<b>Date Issued :</b>	December 11, 2024	<b>PCN Number :</b>	516322
<b>Reason for Change :</b>	Change to Product		
<b>Description of Change :</b>	The tolerance of the mounting hole $\varnothing 3+0.2$ is widened to $+0.3$ - adaptation of the documents to the product - no critical dimension		
<b>Reason for Short Notice :</b>	Special Request		
<b>Assessment of Change :</b>	No change to parts - Form/Fit/Function		
<b>Planned Implementation Date :</b>	January 06, 2025		
<b>Customer Sample Availability Date:</b>	December 06, 2024		
<b>Last date to request Samples by Customer :</b>	December 13, 2024		
Please note if Samples are not requested as per Customer Samples Request date, it may take additional 4-6 weeks to arrange Samples.			
<b>Traceability Code Markings / Date :</b>	No special marking on the product or packaging

## Before and After

Before in Yellow – After in Red (Mounting Hole)

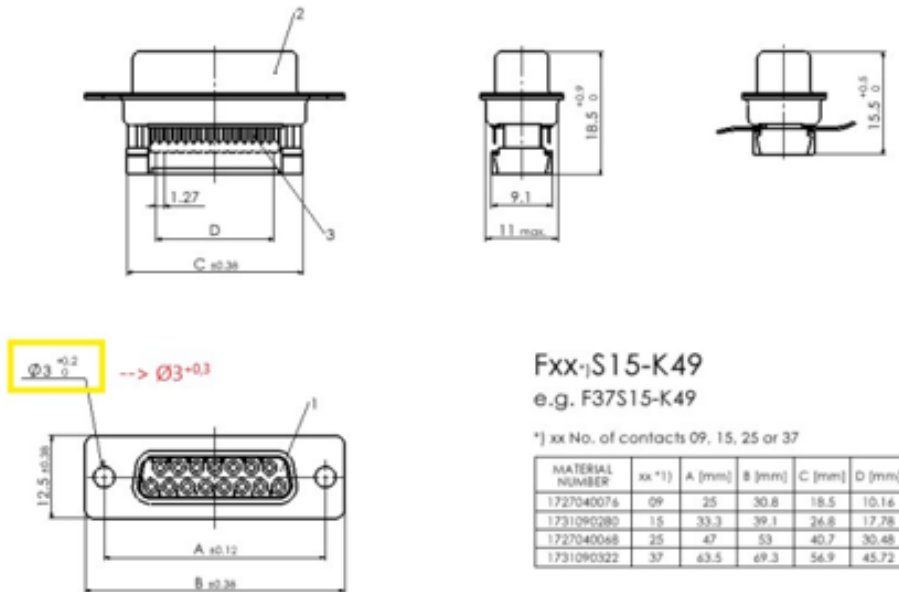
We are updating the datasheets as the tolerance of the mounting hole  $\text{Ø}3+0.2$  is widened to  $+0.3$  - adaptation of the documents to the product - no critical dimension
